Access Compliance Report

Public Rights-of-Way

(Curb Ramps)

Intersection ID: 4312	Main Street: RADBOURNE BV	Cross Street: W W T HARRIS BV	Location: NW
ADA ID: 1290F55CC24E	Ramp Type: Perp	Initial Pass/Fail: Fail	Overall Compliance: No
			Severity Score: 40

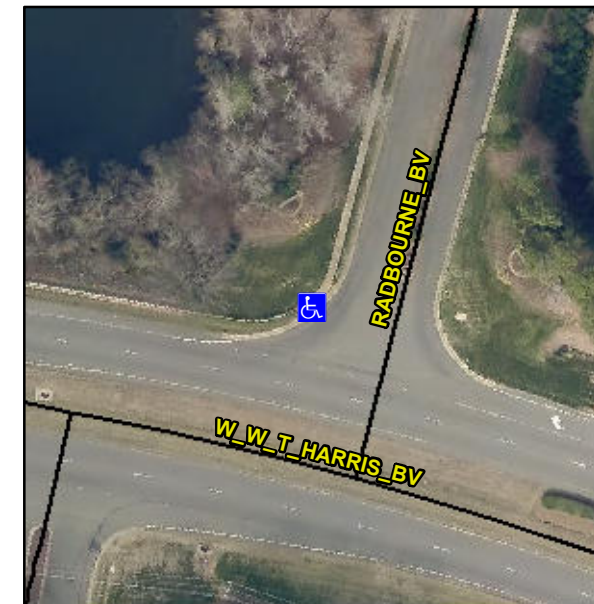
R304.2.2, R304.5.3, R302.7

Compliance	Description	Data	Compliance	Description	Data
N/A	Ramp Length (in)	60.5	No	Ramp Slope (%)	11.1
Yes	Ramp Width (in)	48.0	No	Ramp XSlope (%)	5.7
N/A	Flare Type LT	N/A	N/A	Flare Type RT	N/A
N/A	Flare Slope LT (%)	N/A	N/A	Flare Slope RT (%)	N/A
N/A	Flare Traversable LT?	N/A	N/A	Flare Traversable RT?	N/A
N/A	Landing Length (in)	N/A	N/A	DWS Provided?	N/A
N/A	Landing Width (in)	N/A	N/A	DWS Contrast?	N/A
N/A	Landing Slope (%)	N/A	N/A	DWS Length (in)	N/A
N/A	Landing X Slope (%)	N/A	N/A	DWS Full Width?	N/A
N/A	Landing Curb? (Y/N)	N/A	N/A	DWS Offset (in)	N/A
N/A	Shared Landing?	N/A			
N/A	Gutter Ponding?	N/A	N/A	Gutter Slope (%)	N/A
N/A	Gutter Lip Ht (in)	N/A	N/A	Gutter X Slope (%)	N/A
N/A	Painted X Walk1?	No	N/A	Painted X Walk2?	N/A
	X Walk 1 Direction	To SE		X Walk 2 Direction	N/A
N/A	X Walk 1 Width (in)	N/A	N/A	X Walk 2 Width (in)	N/A
	X Walk 1 Slope (%)	1.5		X Walk 2 Slope (%)	N/A
	X Walk 1 X Slope (%)	6.9		X Walk 2 X Slope (%)	N/A

N/A	Ramp inside XWalk1?	N/A	N/A	Ramp inside XWalk2?	N/A
	Road Slope (%)	N/A	N/A	Clear Space?	N/A
	Road X Slope (%)	N/A	N/A	Clear Space to XWalk (in)	N/A
N/A	Any Obstructions?	N/A	N/A	Storm Grate/Utility Hazard?	N/A
	Obstruction Type			Storm Grate/Utility Type	
		N/A			N/A
		No		Surface Condition? (G/P)	Poor

Remove & Replace Entire Ramp.
